MEDIC UPDATE

TECHNICAL SERVICE BULLETIN

SUBJECT : A/C CONDENSER DAMAGE		No: TSB-00-55-001REV	
		DATE: May, 2000	
		MODEL See below	
CIRCULATE TO:	<input type="checkbox"/> GENERAL MANAGER	<input checked="" type="checkbox"/> PARTS MANAGER	<input checked="" type="checkbox"/> TECHNICIAN
<input checked="" type="checkbox"/> SERVICE ADVISOR	<input checked="" type="checkbox"/> SERVICE MANAGER	<input checked="" type="checkbox"/> WARRANTY PROCESSOR	<input type="checkbox"/> SALES MANAGER

This bulletin supercedes TSB-00-55-001, issued April, 2000, to correct the condenser fan shroud assembly part number. The correction is indicated by "►."

FAN SHROUD MODIFICATION

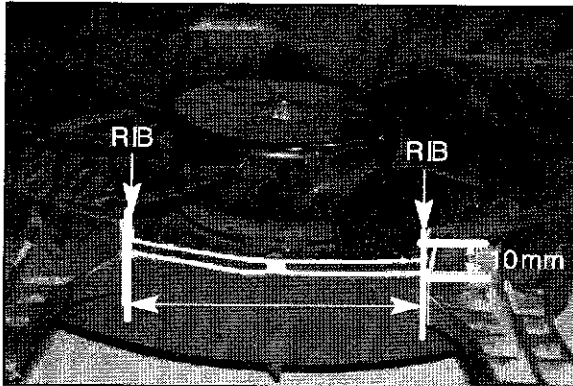
3a. Remove the fan shroud assembly from the vehicle. Then remove the fan. Refer to Group 55 in the appropriate Montero Sport service manual.

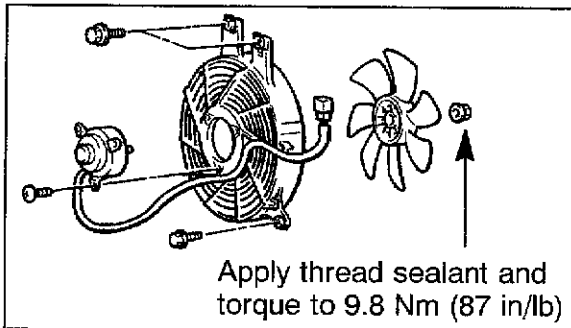
b. Cut material from the lower fan shroud as shown. The cut should be 10 mm deep and 108 mm across (between the ribs).
